**KNOXVILLE HISTORIC ZONING COMMISSION
STAFF REPORT - CERTIFICATE OF APPROPRIATENESS APPLICATION**

PROPERTY ADDRESS: 953 E Moody Ave

FILE NO.: 2-H-19-HZ

MEETING DATE: 2/21/2019

SOUTH HIGH SCHOOL H-1 SITE PLAN
953 S. Moody Avenue
2/21/2019

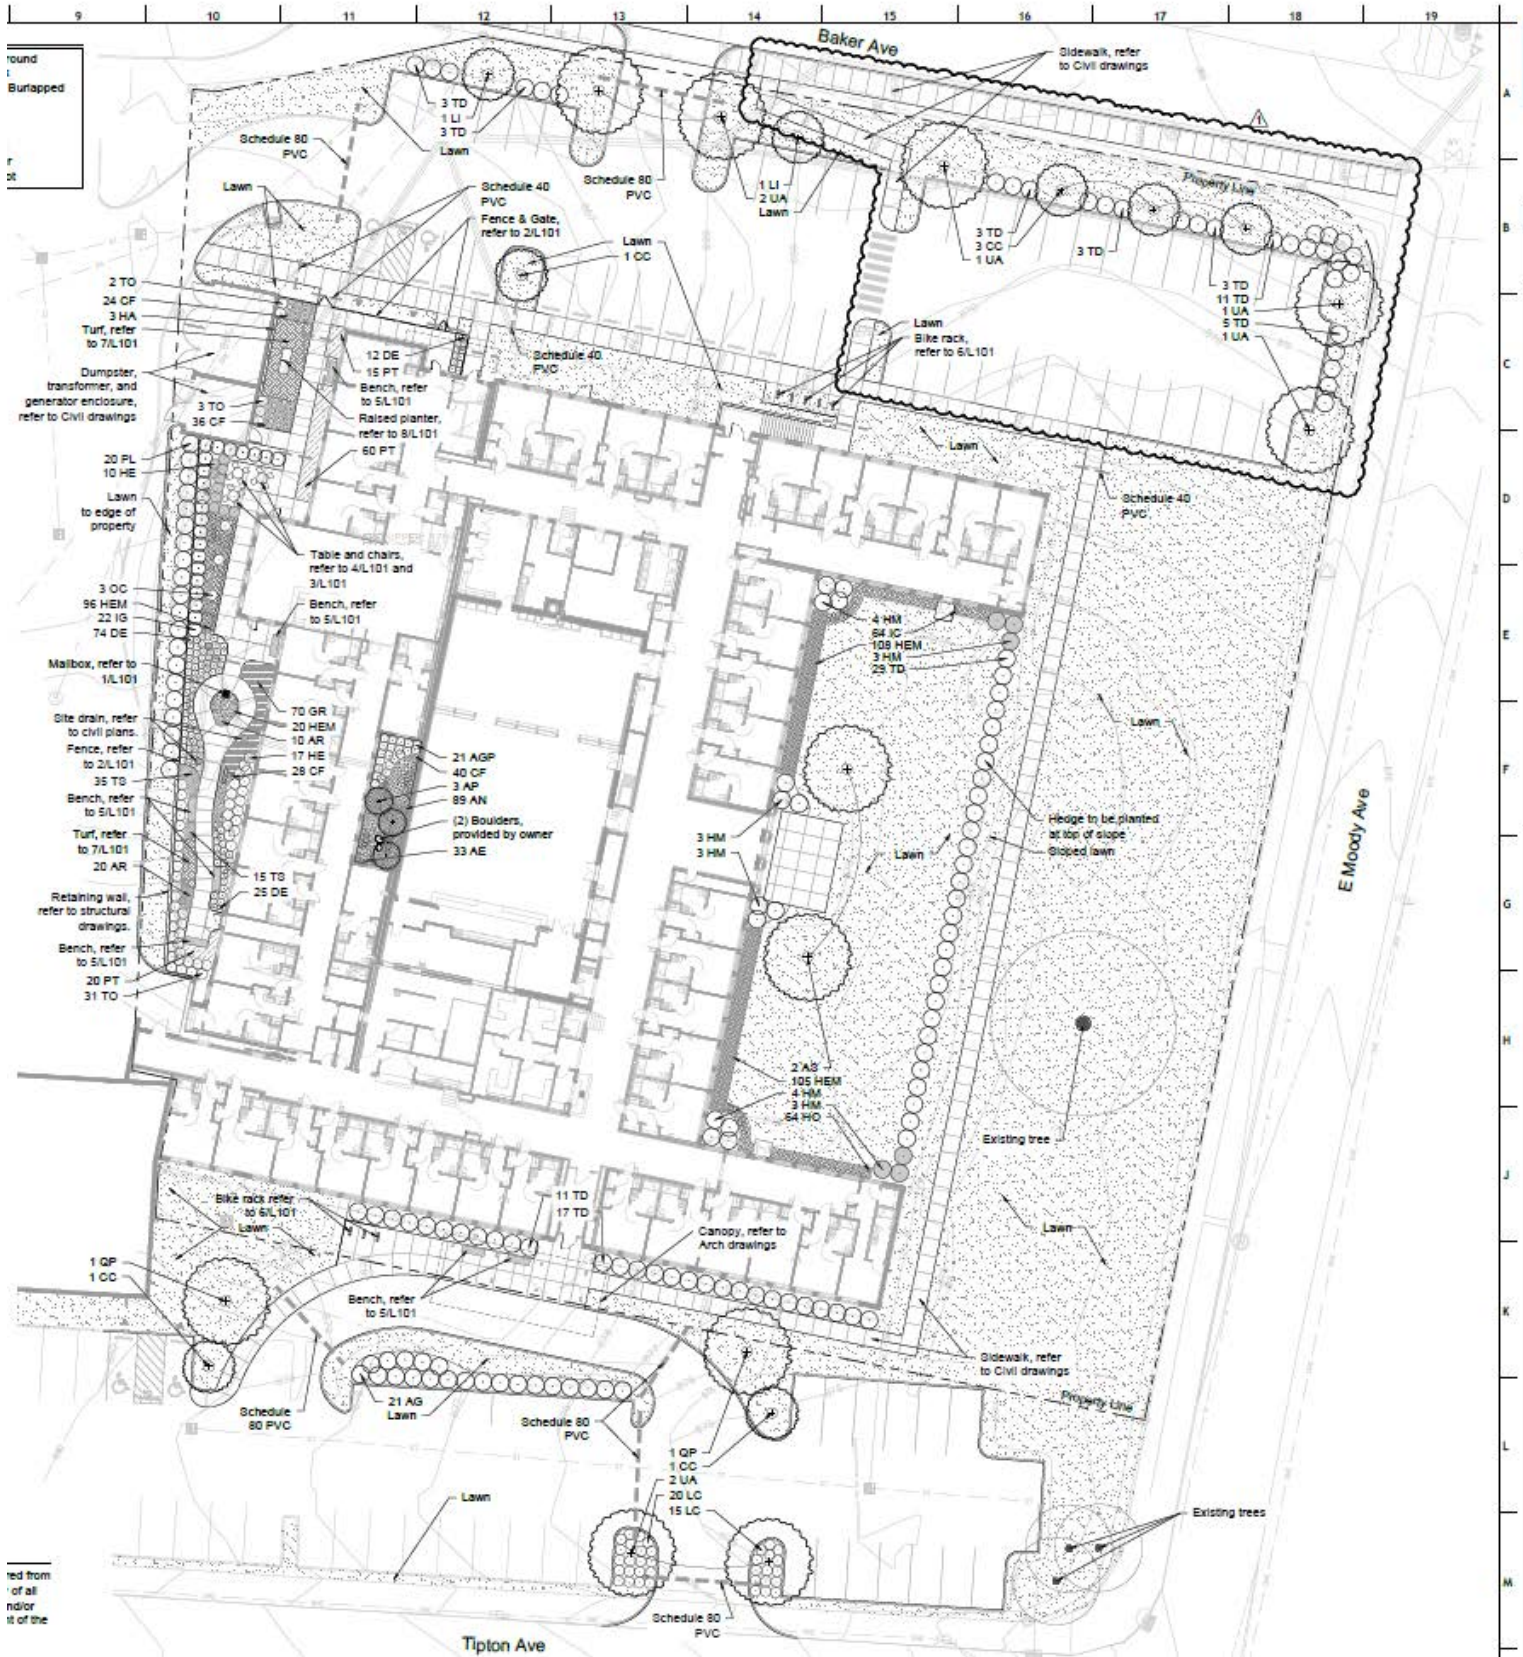
4. The rear addition dating to sometime in the 1940s was not architecturally significant, and the replacement building will be in the same location, constructed to the same height and size. The brick and fiber cement board sheathing will distinguish the new building from the historic main building.

5. The new metal entry canopy on the west side will not be attached to the building, so may be easily removed. The contemporary design will distinguish it as a new structure and will not compete with the historic façade.

SOUTH HIGH SCHOOL H-1 LANDSCAPING PLAN
953 S. Moody Avenue
2/21/2019

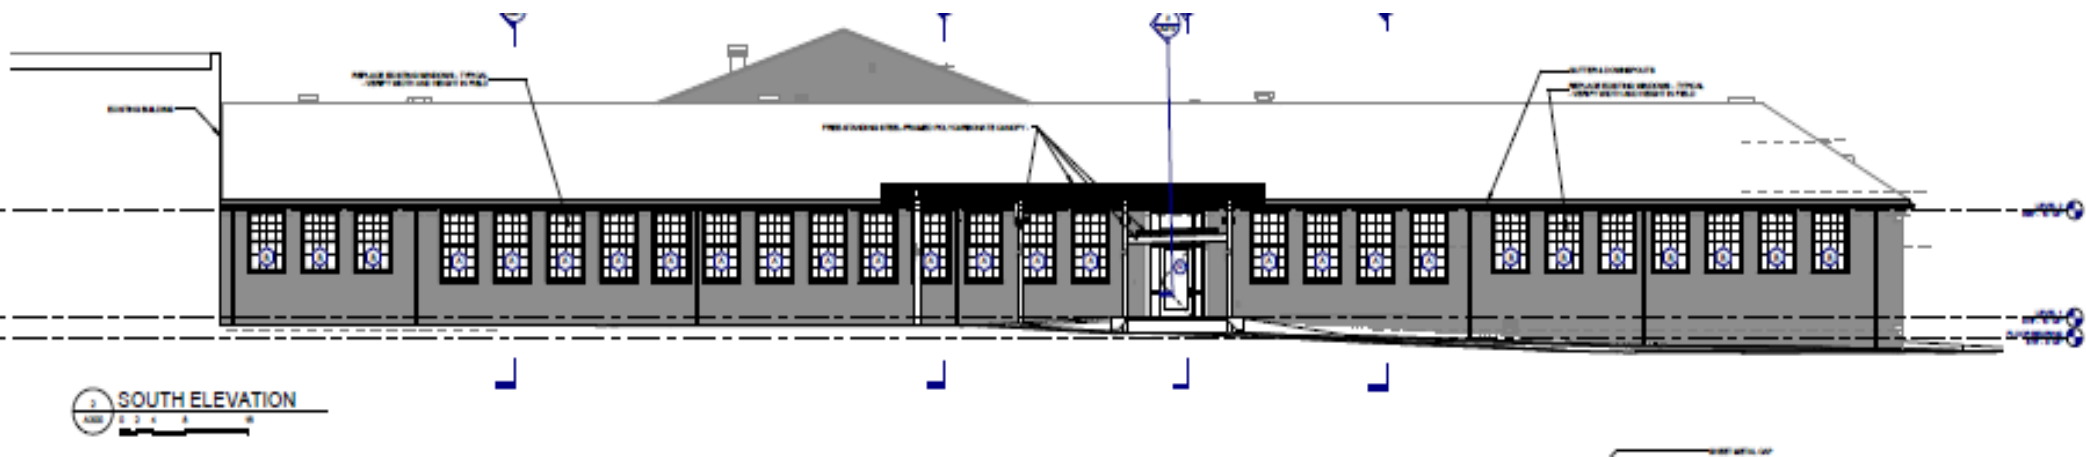
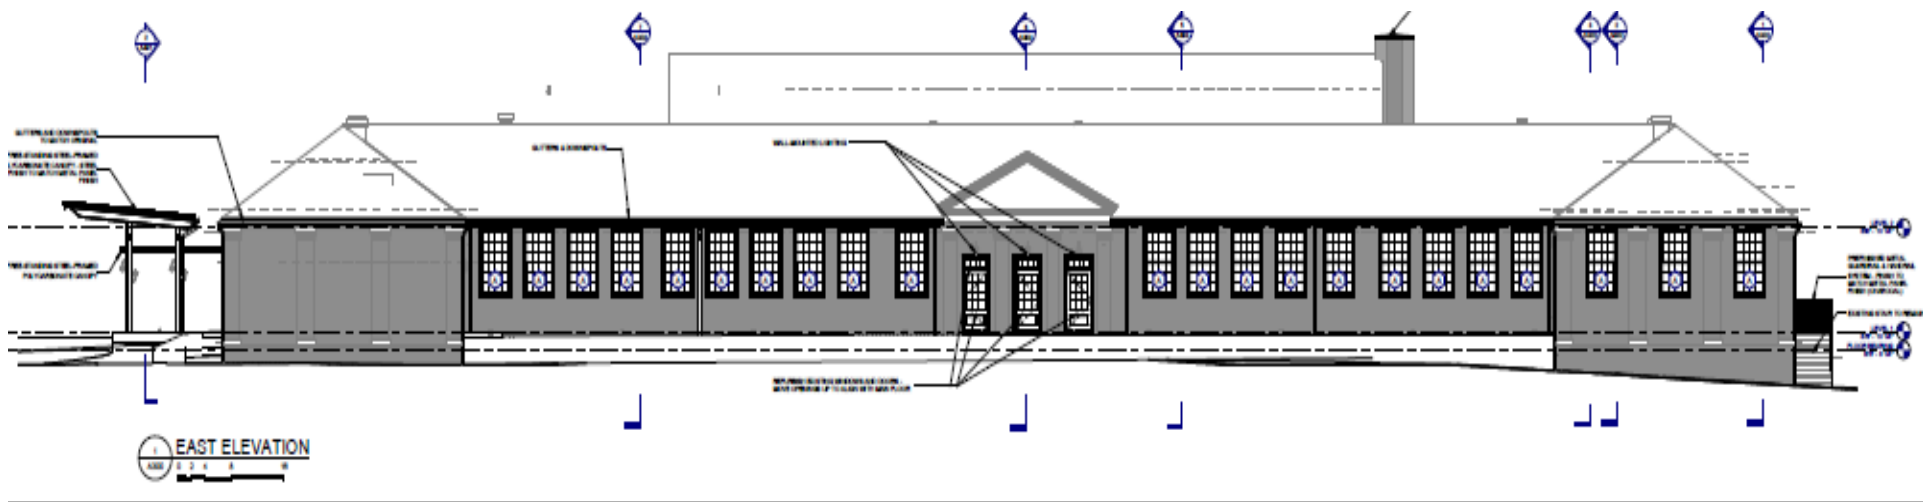
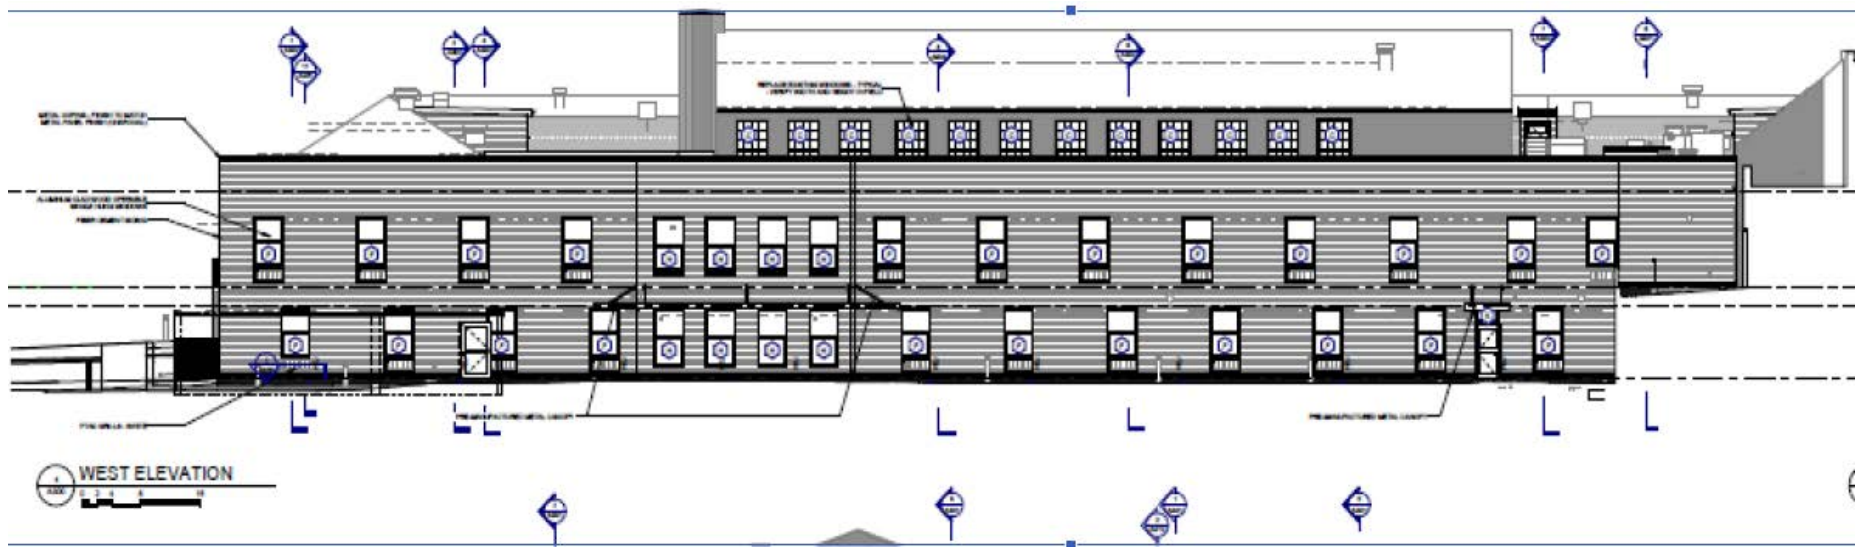
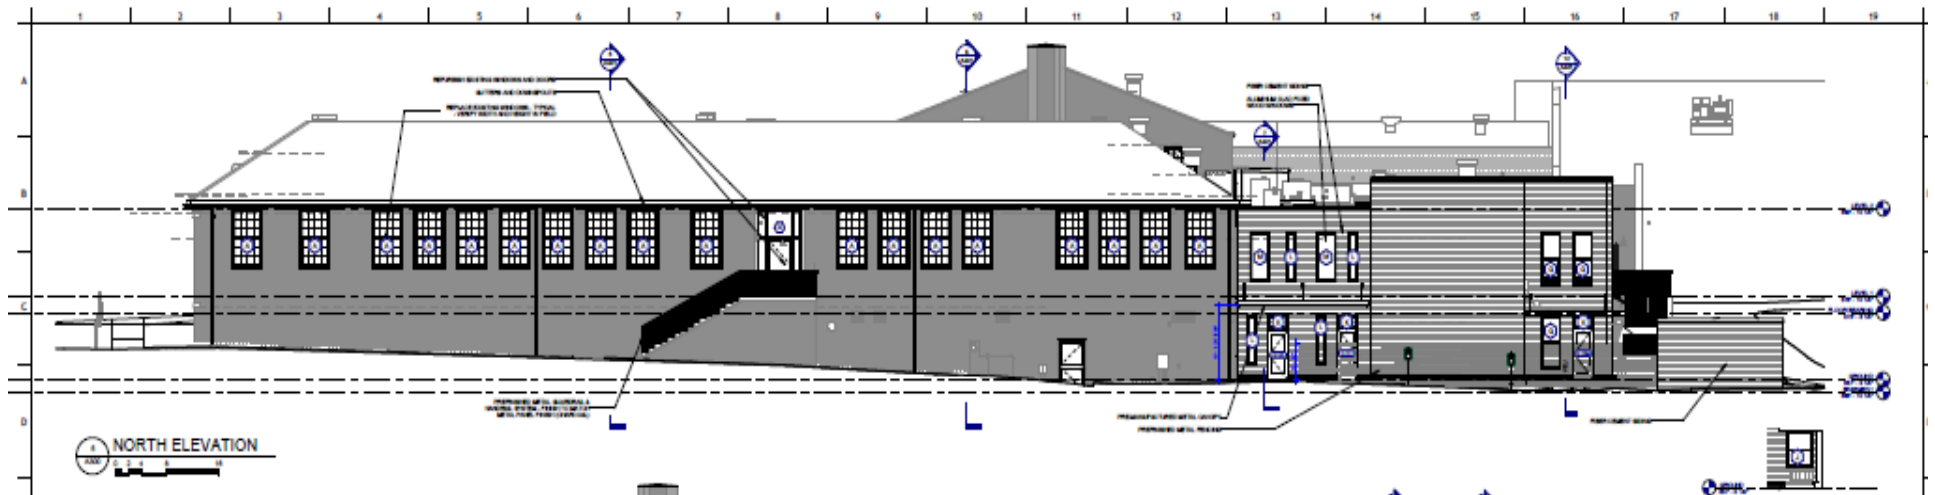
6. The proposed landscaping retains the original grassy front lawn of the school.
